ENGINEERING CHANGE NOTICE NO.

03933

DWG NO. 647.9700

DWG TITLE: CUTTER SUB ASSYS

SHEET 7, ZONE C1 IS:

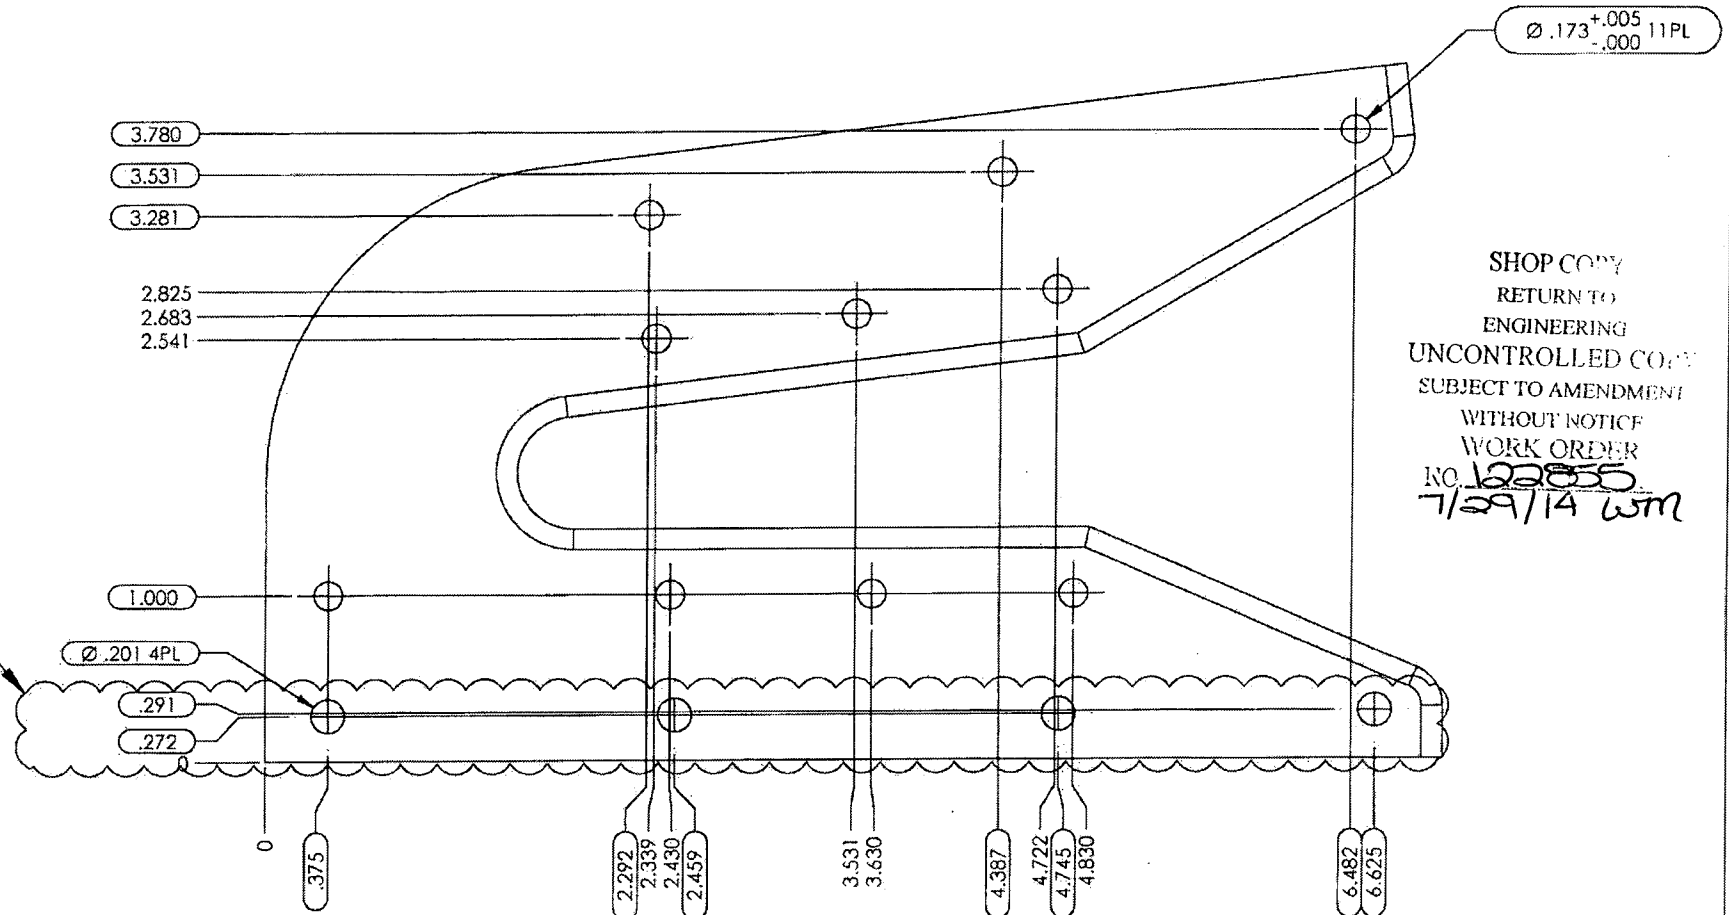
REASON: CORRECTED DIMENSIONAL ERROR.
